## **NorthConnex Application Number: SSI 13\_6136**

Please find below my submission in response to the exhibition of the **EIS for the proposed NorthConnex tunnel project**.

**Figure 7: Option Preferences from Community Consultation.**

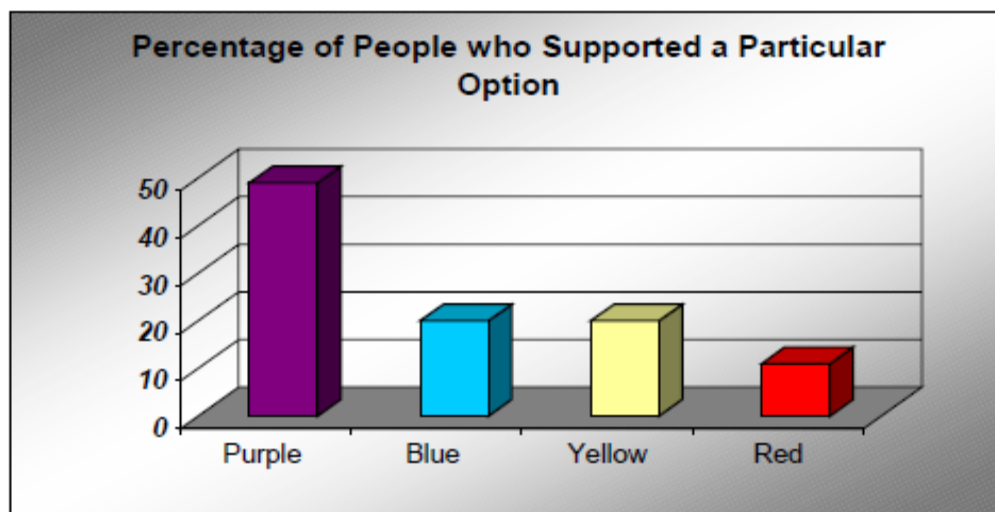
- The Purple option (of the four considered) **minimizes the effects on properties and occupiers**, which includes residential homeowners, schools, commercial businesses, and aged care facilities (Table 6, *F3 to Sydney Orbital Link Study Report*, p.21).
- Crucially, the preferred (**Purple**) option was **overwhelming supported by stakeholders in the consultation process** (see Figure 7 below). From my attendance at public meetings and discussions with residents, **this remains the preferred option, with an extension of the tunnel to the north.**
